**ADB Loaned Jilin Yanji Low-Carbon Climate-Resilient
Healthy City Project**

INCEPTION REPORT

Draft, 30 June 2021

Consulting Services for Low-Carbon City Action Plan preparation, Traffic Impact Assessment, Modelling and Evaluation, Parking Management Study and for BRT Operation Capacity Development and BRT Network Planning, and Pedestrian and Bicycle and Universal Design Master Planning

自行车道处的出租车上下客点不建议设置，也没有需要

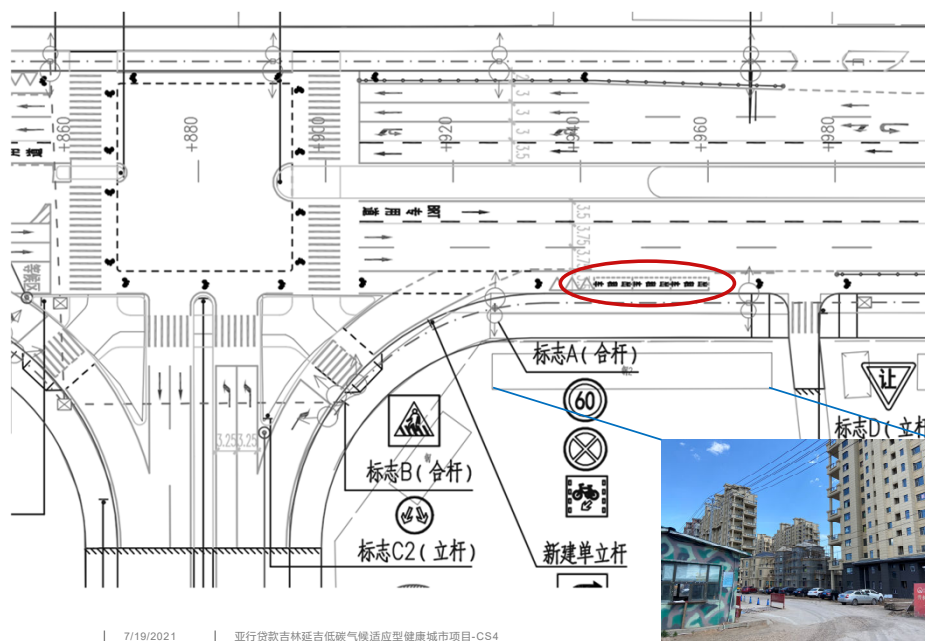
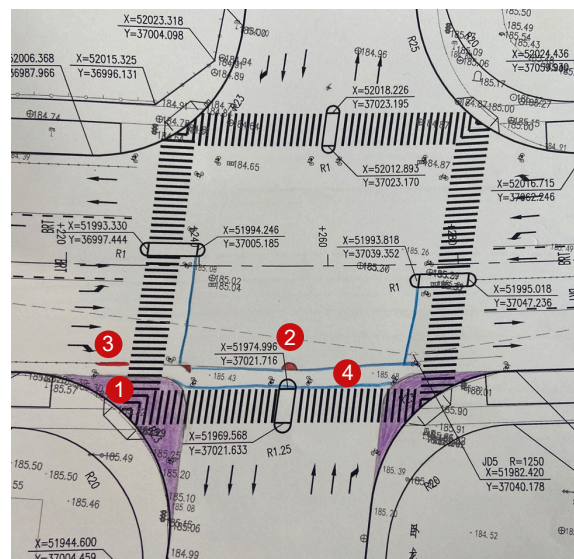
有的出租车停靠位置在自行车道上，基本上挡住了骑车人，增加了开车门与自行车的安全隐患。而且，很多这些停靠点的位置并没有需求。以左图为例，这样的临时停靠点应该取消。

下图的建筑就离开路边一段距离，出租车完全可以开进去这里上下客。

3标段的行人过街和交叉口处的自行车坡道

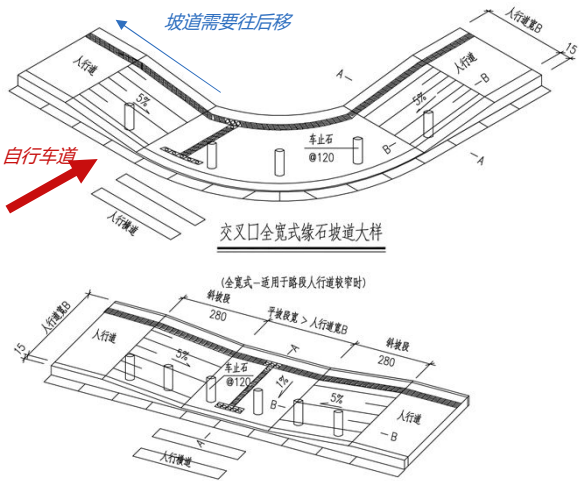
3标段的自行车道设置于人行道, 在交叉口和人行过街位置也需要考虑自行车道。现在的设计中, 骑车人需要从坡道出通过。因此, 自行车道在过交叉口和过街位置应该用标线、路面颜色清楚的表示出来。

出入口位置的自行车道和人行道

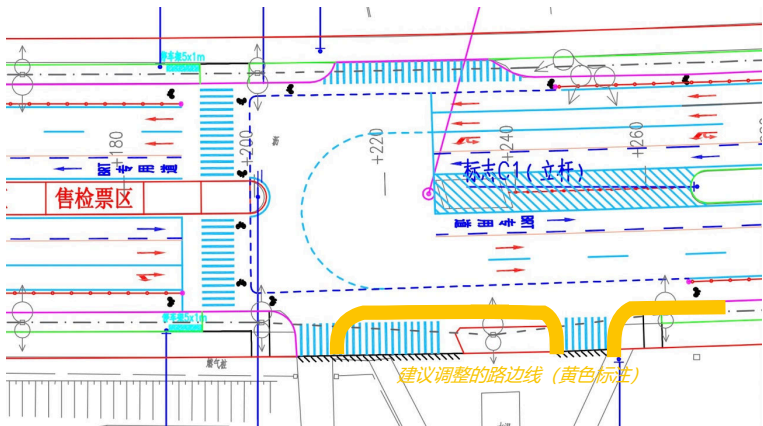
该位置道路平面设计中包括了几个没有必要的、过于宽的开口。建议维持道路边线（不要缩进去），这样会造成过街距离过长，对于行人和自行车有危险。建议减小开口距离，保证最低通过需求就行（如下图黄线所示）。

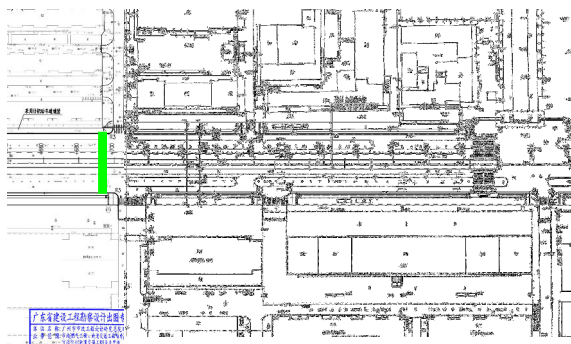
上图: 左侧绿线表示建议的行人过街, 通过中央绿化带可以进站 (虚线部分)

B16 站位于延大, 也是客流最大的其中一个站。设计的进站位置只有东侧一个, 行人要步行60米距离进出站。建议在西侧 (园林胡同) 增加一个进出站。这样可以减少从西边过来进出站乘客的步行距离, 从目前的570米减少到350米, 同时也是一个高需求的路中过街设施 (每小时约1000人流量, 2021年5月14日下午4:26做的一个5分钟调查数据)

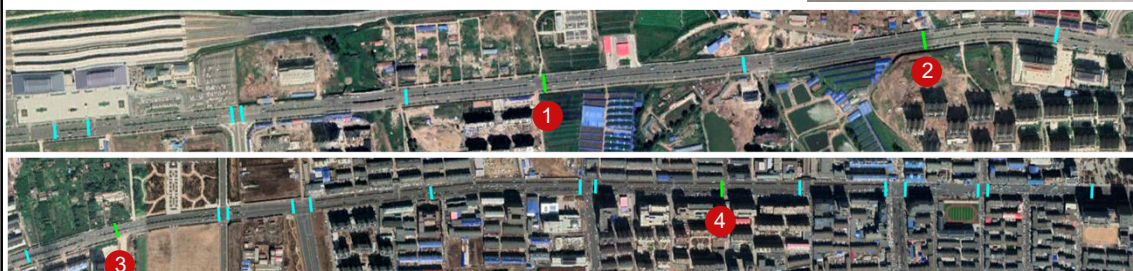
BRT走廊沿线有的路段行人过街间距太长，其中一个超过800米。本次建议新增4个行人和自行车过街设施，如下图绿色线条所示。过街1/2/3采用非信号控制，在BRT车道和社会车道之间设置2个安全岛。如右图所示。过街4建议和B16号站结合，见上一页内容介绍。

右图：为了保障行人和骑车人更好的安全性，建议在社会车道和BRT车道之间增加安全岛。安全岛应有1.5米宽，足够长度以供自行车通过，两端设置岛头设施和标线。
